2000 Corvette: Service Bulletin: Left Headlamp Door Does Not Stay Closed

Number: 00-08-42-002

Subject: Left Headlamp Door Does Not Stay Closed (Shim Headlamp Door Motor/Actuator and Replace Insulators)

Model Year: 2000 Chevrolet Corvette

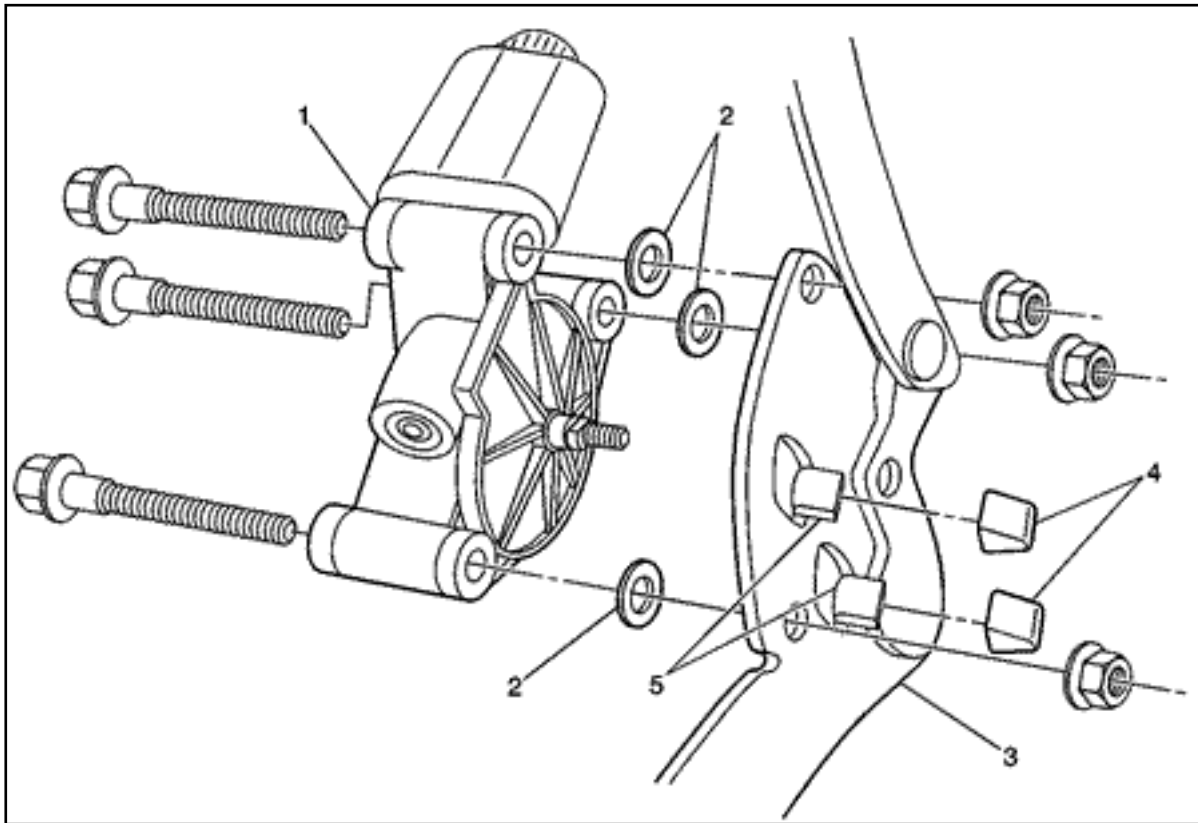
Some customers may comment that the left front headlamp door does not remain closed after the headlamps are turned off. Others may comment that the left headlamp door closes when the headlamps are turned off, but then reopens. In either case, the right headlamp door operates properly.

Install one washer (2) between the left headlamp door motor/actuator (1) and the mounting bracket (3) at each of the three attaching bolt locations. Also replace the insulator (4) on each of the two mounting bracket travel stop tabs (5) as shown. For information on headlamp motor/actuator removal, see the Headlamp Motor/Actuator Replacement procedure in the Lighting sub-section of Body & Accessories in the appropriate Service Manual.
